PARTS & SERVICE NEWS

REF NO.	AT02056
DATE	Jul. 12, 2002

SUBJECT: MODIFICATION PROCEDURE OF WINDOW MOTOR FAILURE ON HM300, 350, 400-1

PURPOSE: To introduce modification procedure to prevent occurrence of failures with the power window related parts on HM300-1, HM350-1 and HM400-1 dump trucks

Fig. 17

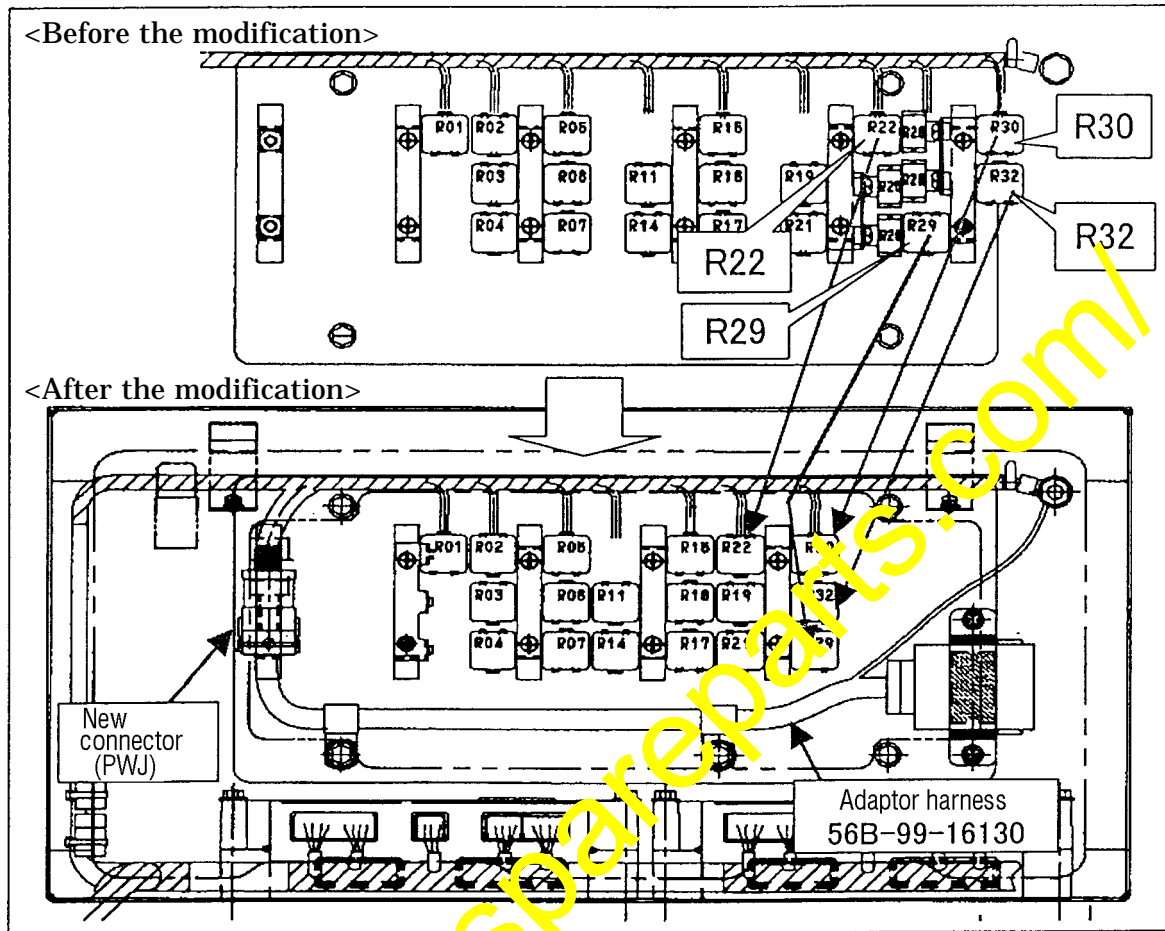
- (4) Changing the layout of the relay connectors (R22, R29, R30 and R32)
 (i) Change the layout of the relay connectors (R22, R29, R30 and R32) as shown below. (Refer to Fig. 17)

Fig. 18

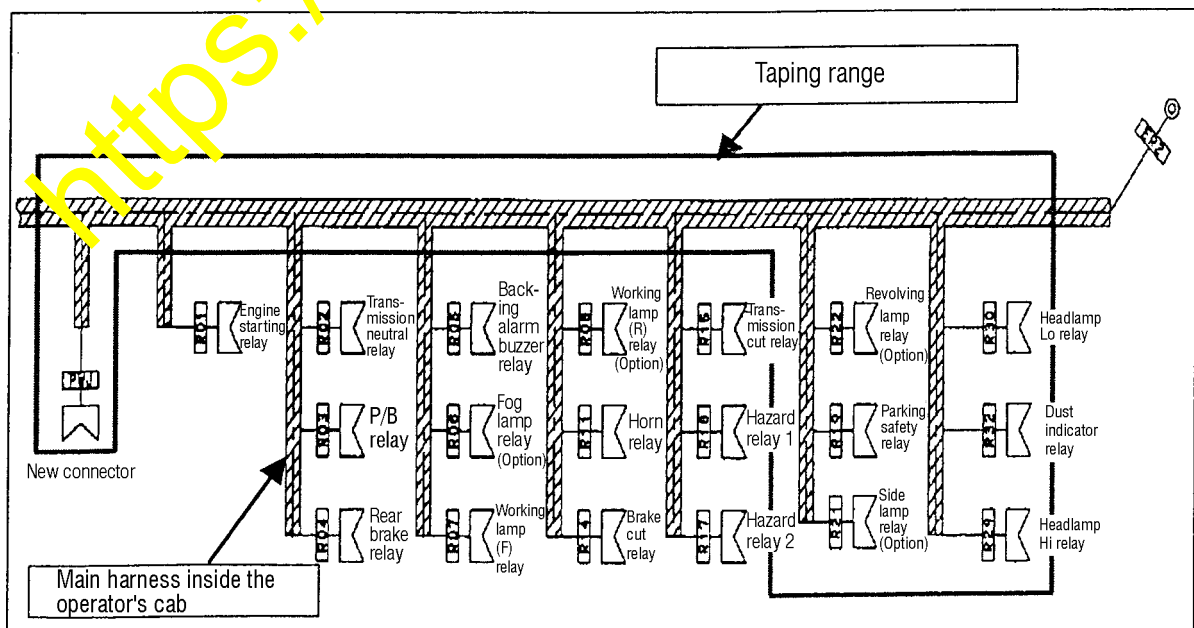
- (ii) Apply insulation taping to the excess leads which became excessive by the above change of the relay layout and to the leads separated as per the above Section 4-3B(2). (Tape No.: 08024-91920) (Refer to Fig. 18)

Fig. 22

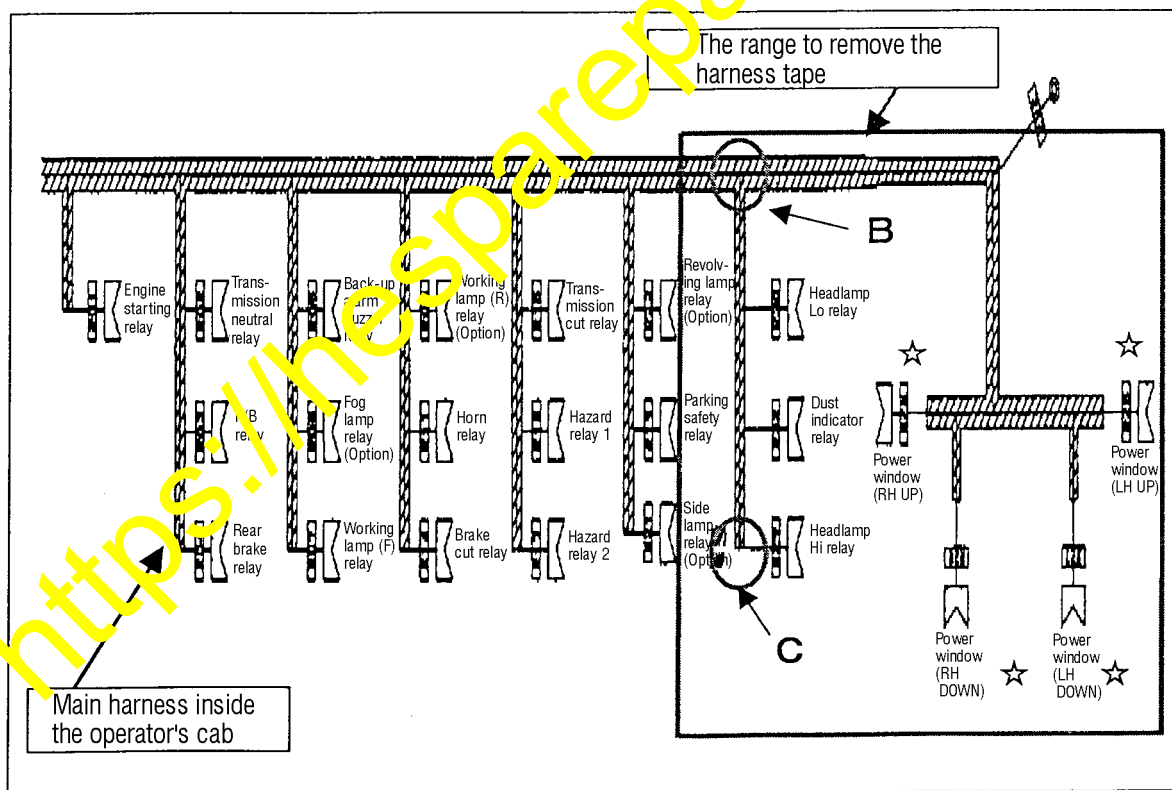
(R25, R26, R27 and R28 : sections marked ☆ in Fig. 22 to the new connector (New R25)

2) Cut the separated leads at the point 150 mm away from the point C, after passing through the section B and section C (Refer to Fig. 22 and Fig. 25) once again at equal lengths (Note 7) and remove the insulation covering by 7 mm.

Fig. 23

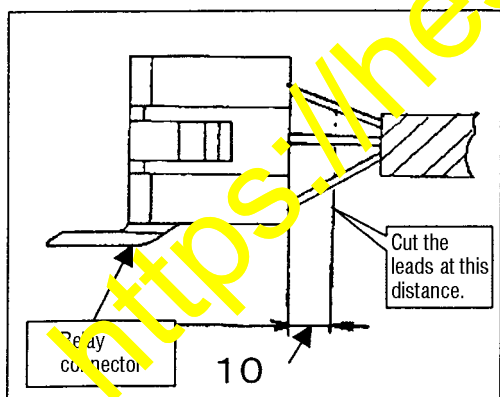
1) Using the nipper or radio pliers, cut to separate the leads at a distance 10 mm away from the relay connector end. (Note 7)

Fig. 25

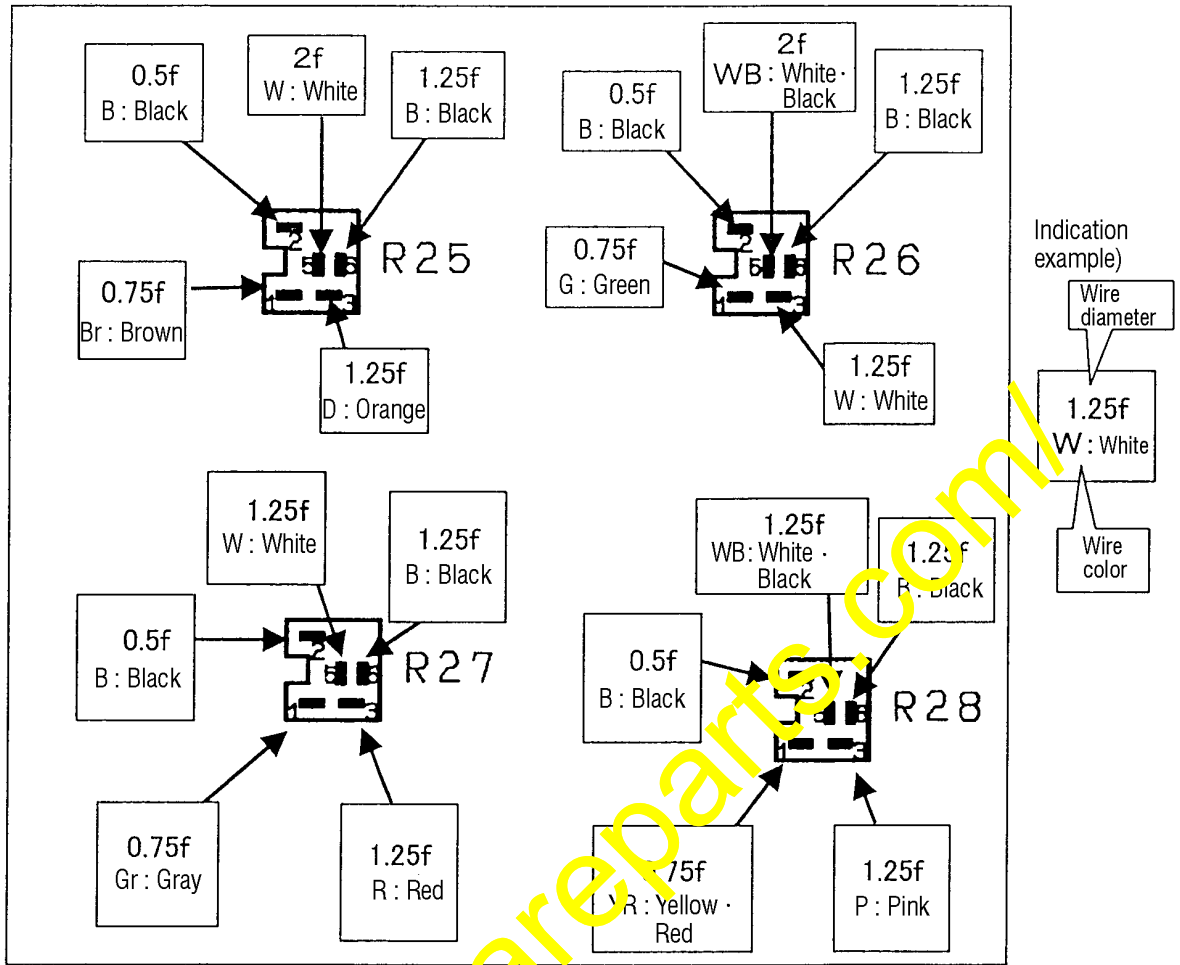
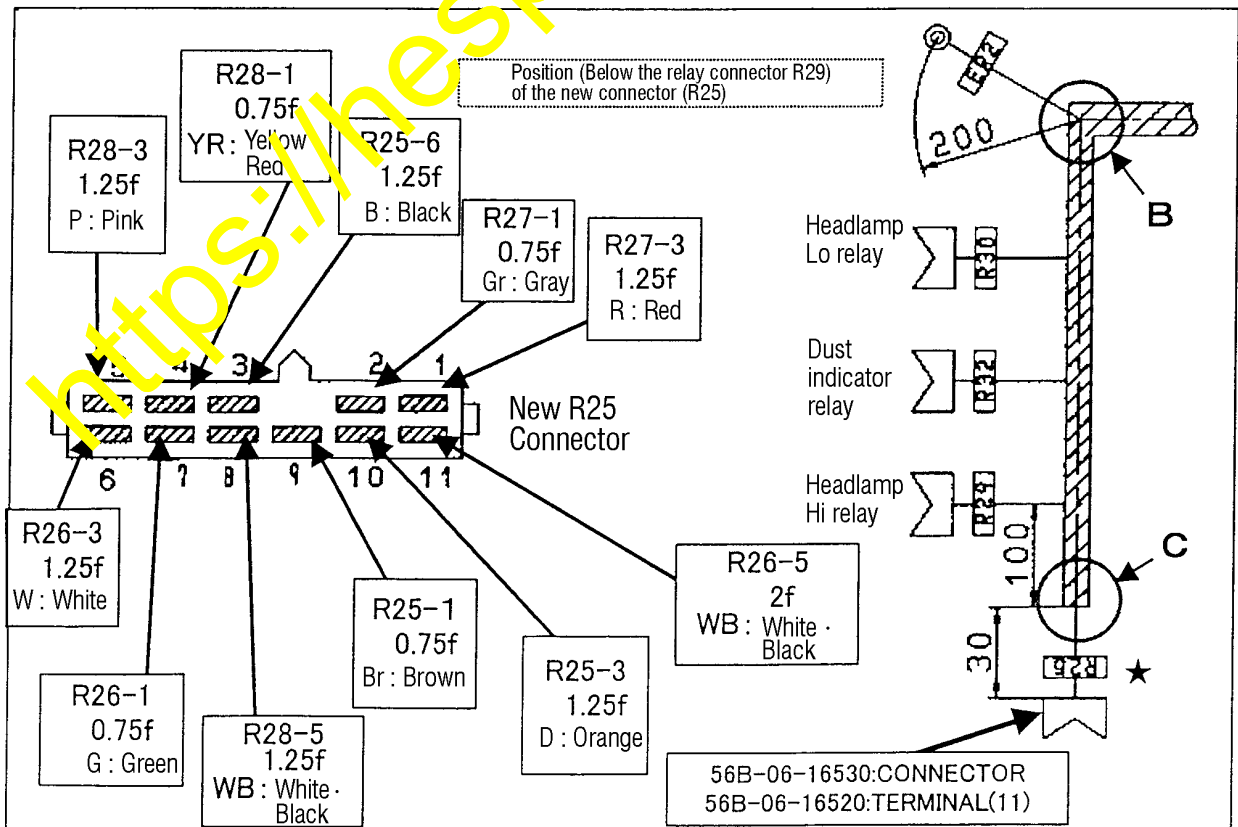
(i) Connect the leads of the relay connectors (R25 through R28) (Refer to Fig. 24) to the centralized connector (New R25). (Refer to Fig. 25.)

4) Install the terminal into the new connector (56B-06-16530) (New R25). (Refer to Fig. 25.)

Fig. 26

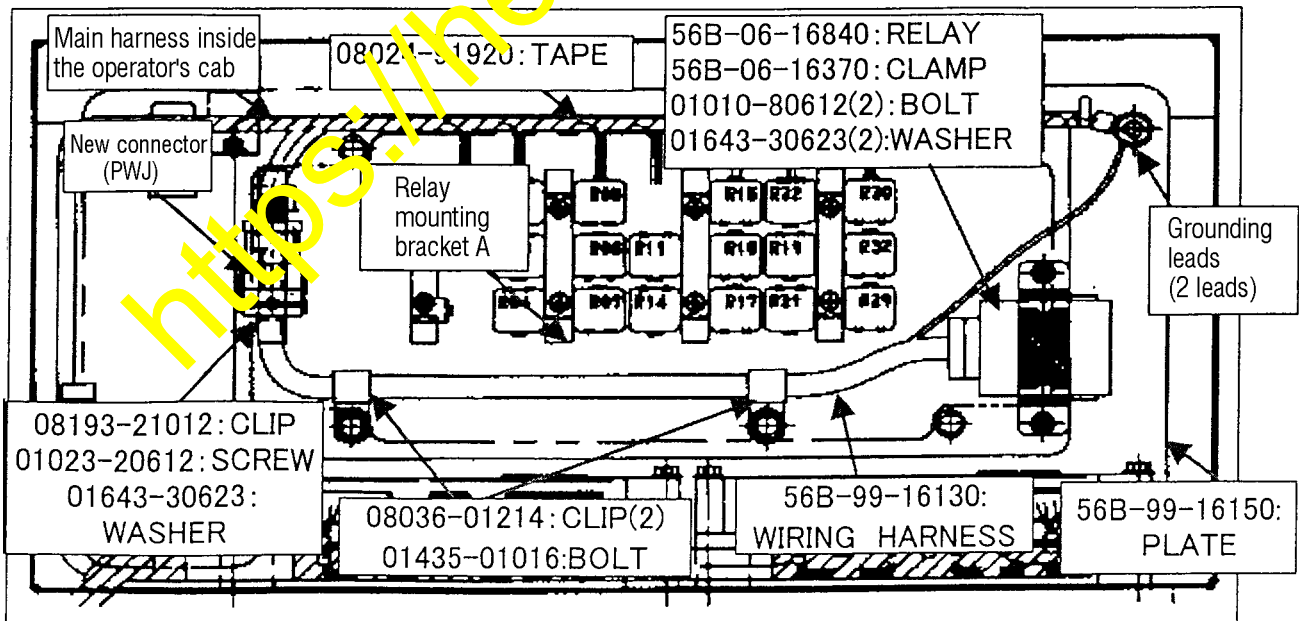
- (1) Paste the cushion sheet (56B-06-16850) for the improved relay (56B-06-16840) to the new relay mounting plate (56B-99-16150). (Refer to Fig. 27.)
- (2) Install the new relay mounting plate (56B-99-16150). Hereafter, refer to Fig. 26.

- (3) Inserting the relay connectors to the relay mounting bracket A, install the relays. (As the mounting parts, reuse the current parts.) (Excluding R25, R26, R27 and R28)

- (4) Fasten the connector (PWJ) which has been added as per 4-3A, B (3) using the clips (08193-21012), screws (01023-20612) and washers (01643-30623).

- (6) Fasten the improved relay (56B-06-16840) using the clamp (56B-06-16370) described in the above Section (5) and using the bolts (01010-80612(2)) and washers (01643-30623(2)).

Fig. 28

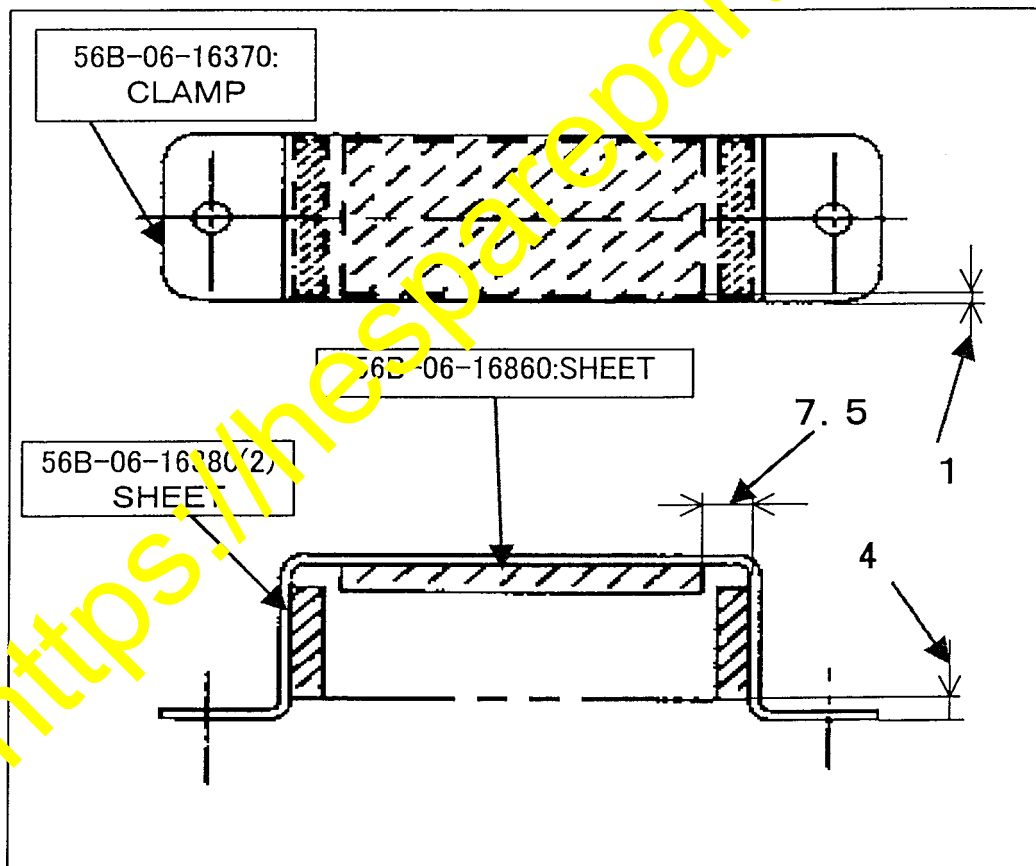
- (5) Paste the cushion sheets (56B-06-16380 (2) and 56B-06-16860) to the mounting clamp (56B-06-16370) for the improved relay (56B-06-16840). (Refer to Fig. 28.)

Fig. 29

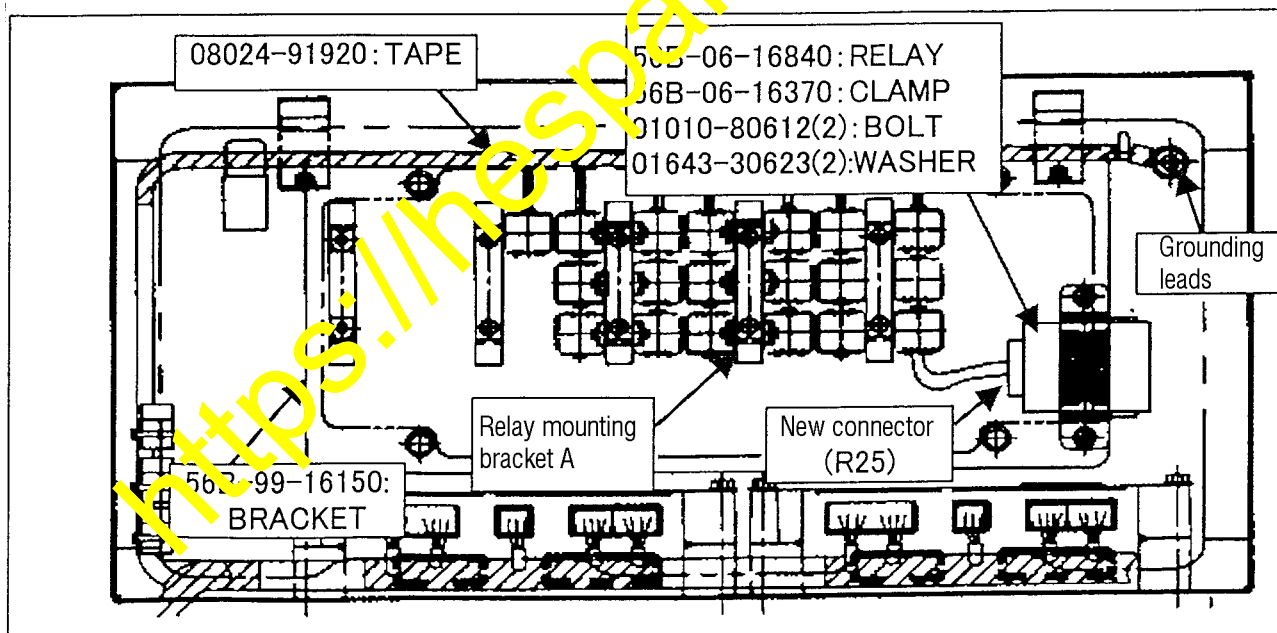
- (1) Paste the cushion sheet (56B-06-16850) for the improved relay (56B-06-16840) to the new relay mounting plate (56B-99-16150). (Refer to Fig. 30.)
- (2) Install the new relay mounting plate (56B-99-16150). Hereafter, refer to Fig. 29.

- (3) Inserting the relay connectors to the relay mounting bracket A, install the relays. (As the mounting parts, reuse the current parts.) (Excluding R25, R26, R27 and R28)

- (5) Fasten the improved relay (56B-06-16840) using the clamp (56B-06-16370) described in the above Section (4) and using the bolts (01010-80612(2)) and washers (01643-30623(2)).

Fig. 31

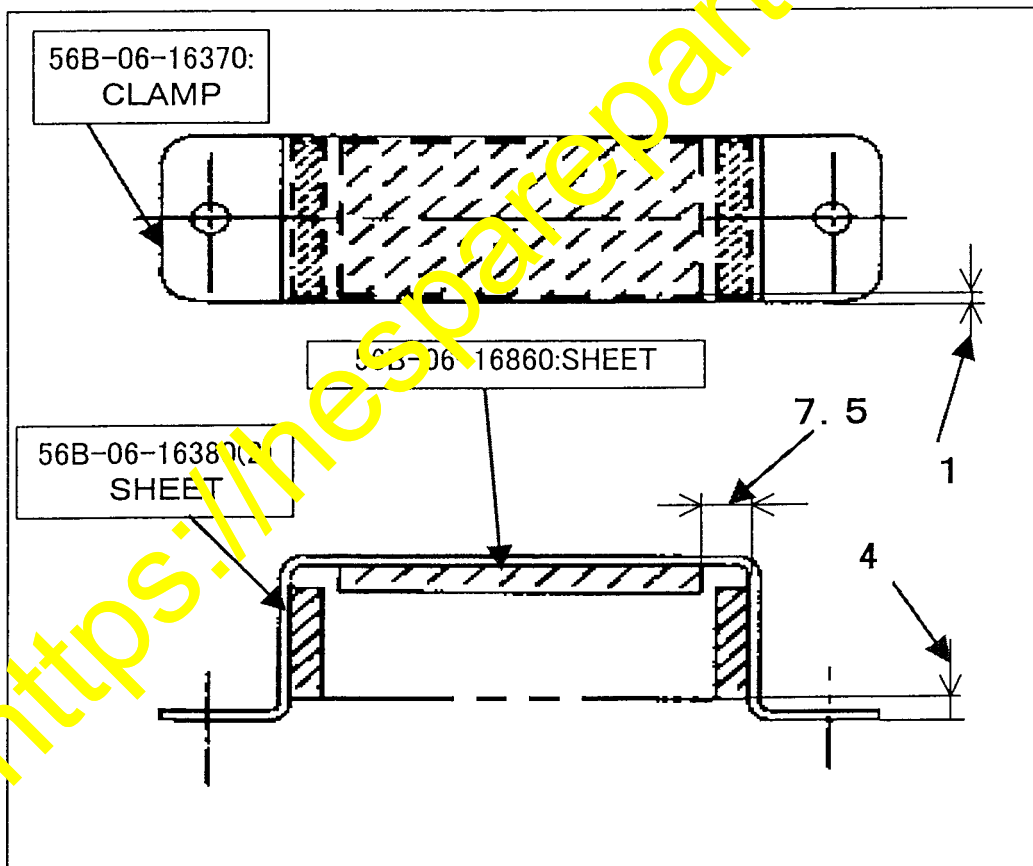
- (4) Paste the cushion sheets (56B-06-16380 (2) and 56B-06-16860) to the mounting clamp (56B-06-16370) for the improved relay (56B-06-16840). (Refer to Fig. 31.)

Fig. 36 Relay decal after the print change
(56B-93-11144 --- in Japanese)
(56B-93-12142 --- in English)
(56B-93-18142 --- in Indonesian)

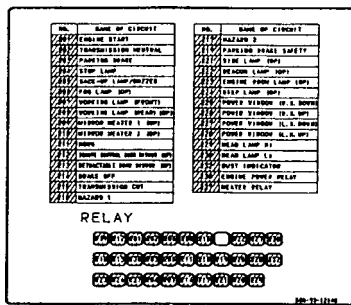
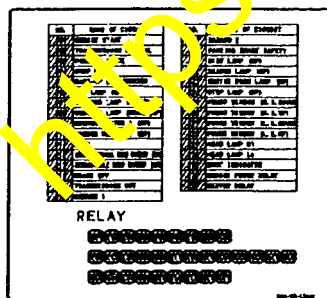
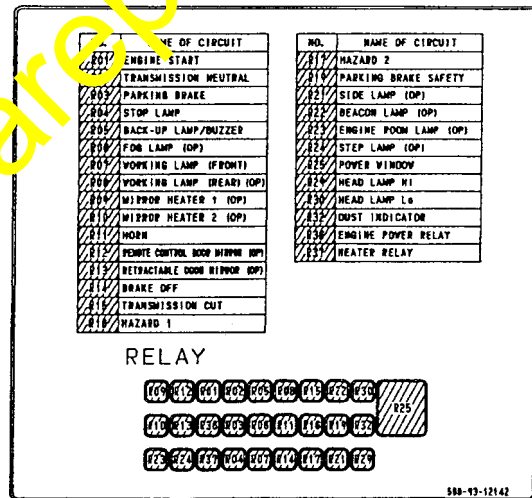
Relay layout change (relays R22, R29, R30, R32, R25, R26, R27 and R28) (Refer to Fig. 34, Fig. 35 and Fig. 36.)
